Cynllun Diwygiedig
Amended Plan

PROPOSED SITE MASTER PLAN
scale 1:500

PROPOSED SITE DEVELOPMENT
7A TO 7D BRYN CLON BUSINESS PARK, BANCON
FOR V.L. J.R. BUSINESS SPACE UNIT 1-7
PROPOSED SITE MASTER PLAN
1:500/0A1

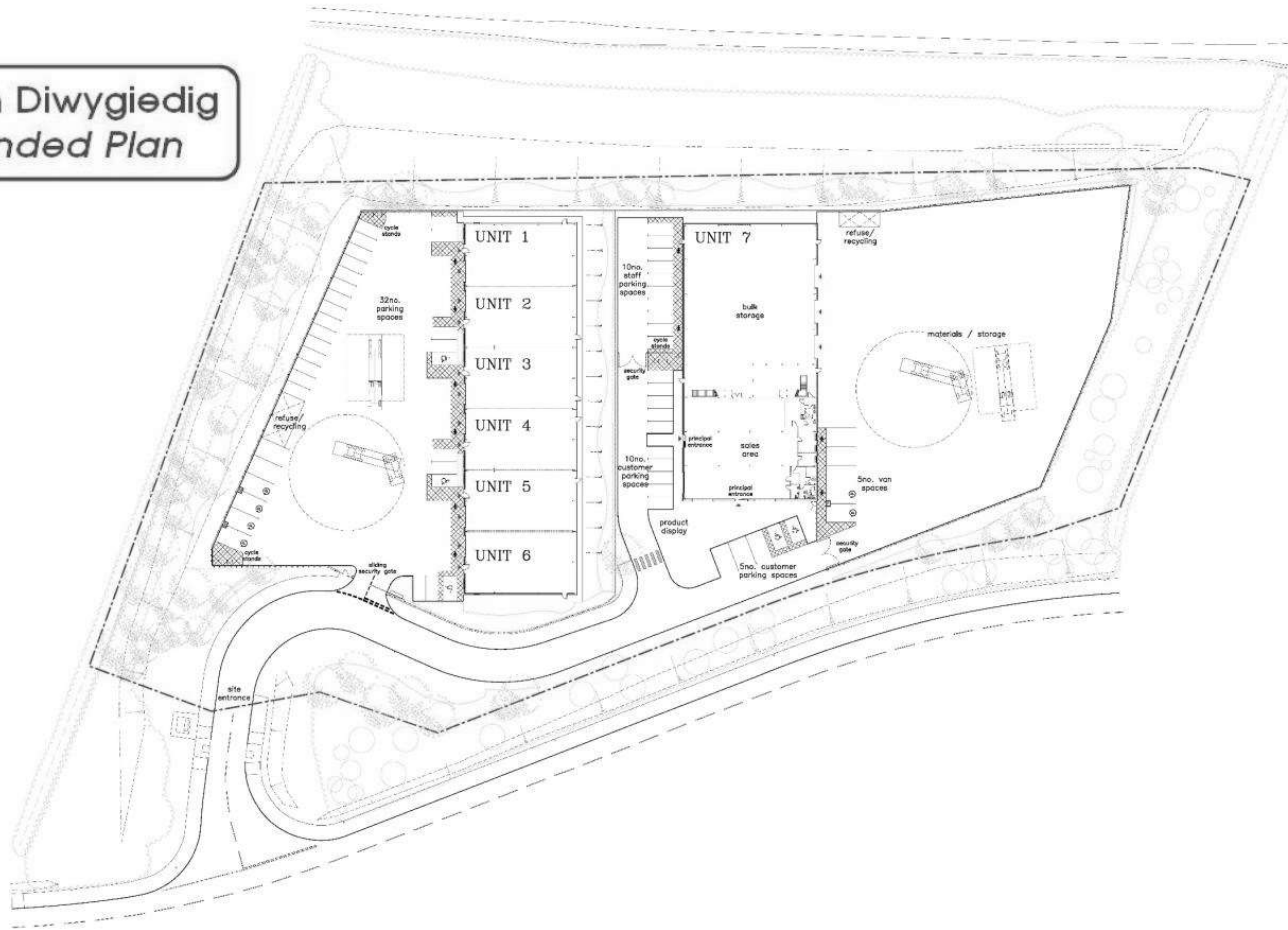
REVISION 1 - 13 MARCH 2023
A SET OF REVISED DIMENSIONS TO UNIT 7 AMENDED TO ADD A LAMP COLUMN TO THE EXISTING BULK STORAGE AREA TO ADD A NEW UNIT IN AREA OF THE ORIGINAL AND EXISTING PROVISIONS.

REVISION 2 - 24 FEBRUARY 2023
ADDITIONAL AREA IDENTIFIED FOR UNIT 7.

REVISION 3 - 5 DECEMBER 2022
REVISION OF UNIT 7 AREA TO ADD SITE ENTRY AND VEHICLE TRAILING SPACE FOR EXISTING PROVISIONS.

REVISION 4 - 18 AUGUST 2022
LOCATION OF UNIT 7 AMENDED TO SITE EXTENT OF MATERIALS YARD TO UNIT 7 AMENDED TO SOUTH EAST CORNER AND HELPING ST RUCKING HEIGHT ID.

REVISION 5 - 16 JUNE 2022
CHANGING DIMENSIONS TO UNITS 1-6 AVAILABLE TO DEVELOPERS WITH PROPOSED YARDS - AMENDED TO VEHICLE TRAILING CORRIDOR TO EXIST.

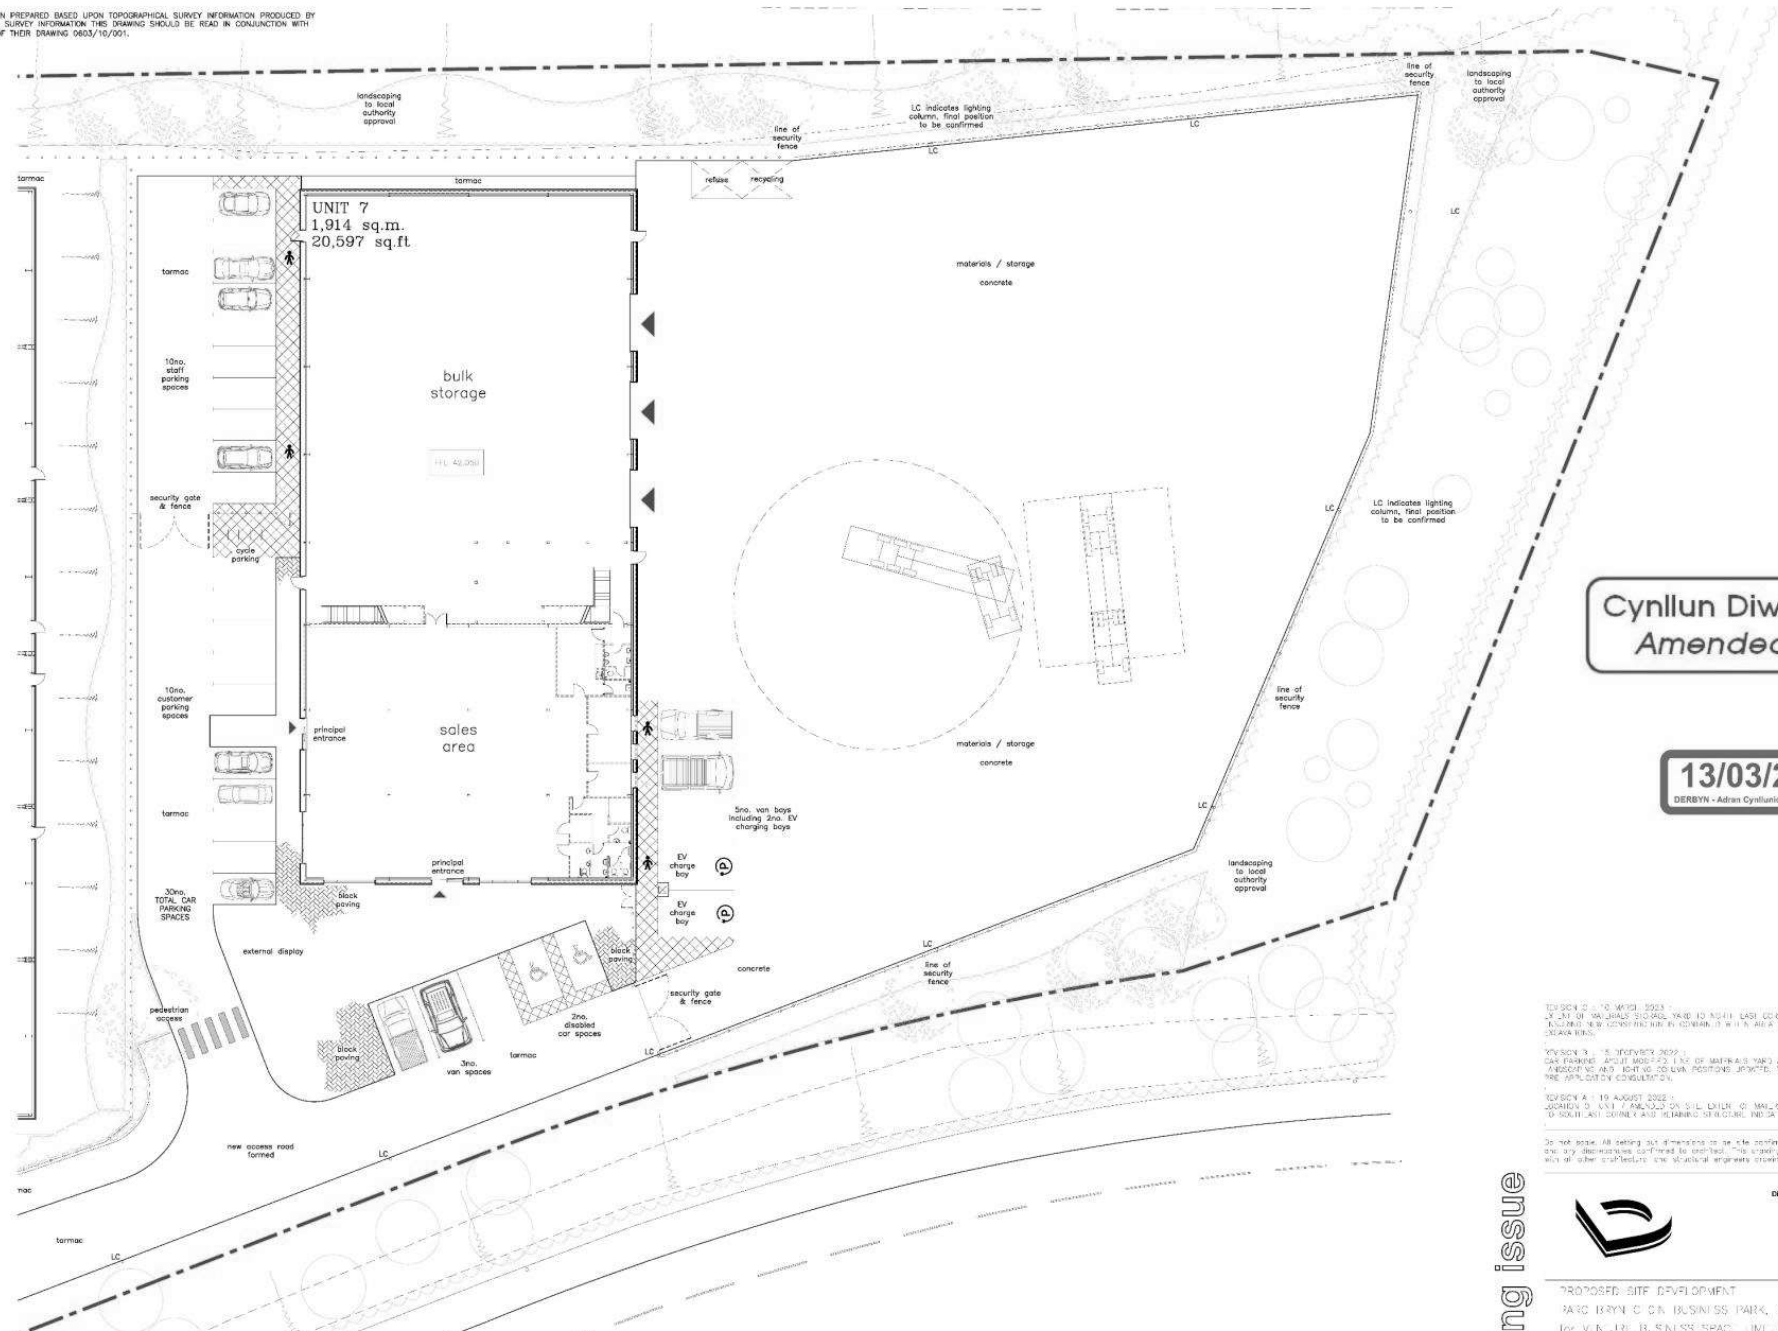
REVISION 1 - 10 MARCH 2023
 1. AS PART OF MATERIALS STORAGE YARD TO NORTH EAST CORNER OF UNIT 7, A NEW ACCESS ROAD TO BE FORMED TO THE EAST OF THE UNIT TO PROVIDE ACCESS TO THE STORAGE YARD.
 REVISION 2 - 15 FEBRUARY 2023
 1. AS PART OF MATERIALS STORAGE YARD AND SECURITY FENCE APPROVAL, PROPOSED NEW FENCE LINE TO BE FORMED TO THE EAST OF THE UNIT TO PROVIDE ACCESS TO THE STORAGE YARD.
 REVISION 3 - 19 AUGUST 2022
 1. CORRECTED UNIT 7 PLAN TO SHOW THE LINE OF MATERIALS STORAGE YARD TO BE FORMED TO THE SOUTH EAST CORNER OF THE UNIT.
 REVISION 4 - 19 AUGUST 2022
 1. CORRECTED UNIT 7 PLAN TO SHOW THE LINE OF MATERIALS STORAGE YARD TO BE FORMED TO THE SOUTH EAST CORNER OF THE UNIT.
